**CONTRACT DOCUMENTS
BOONE COUNTY, MISSOURI
BID NO: 84-15DEC05 Porter Road Low Water Crossing Project**

**ADDENDUM #1
(Issued December 7, 2005)**

PORTER ROAD
 Low Water Crossing Project
PLAN AND PROFILE

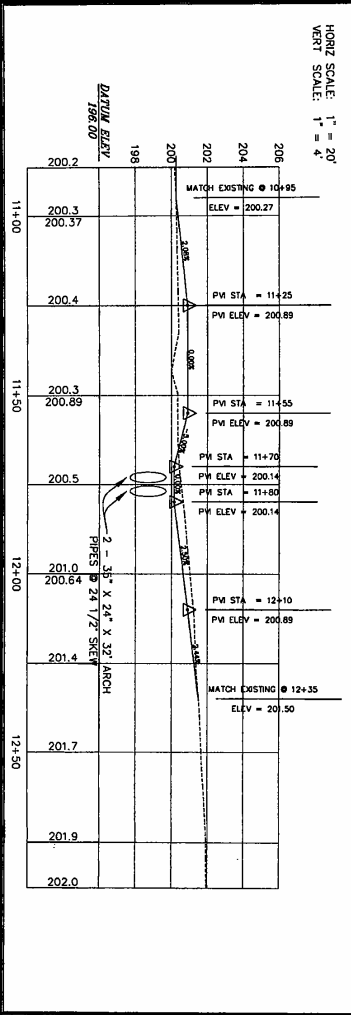
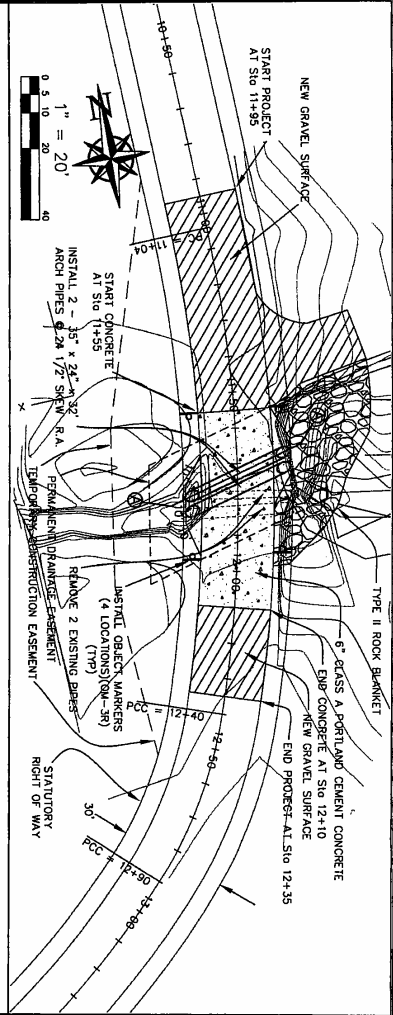
1. **Replace page 2 of 4 of the plan sheets in its entirety** with the attached revised page 2 of 4. Differences shown on the attached revised page 2 of 4 are as follows:

- a. The direction of two of the four object marker signs were corrected.
 - b. The temporary construction easement, which was requested by the residents on the west side of Porter Road, was added to delineate an allowable construction area.
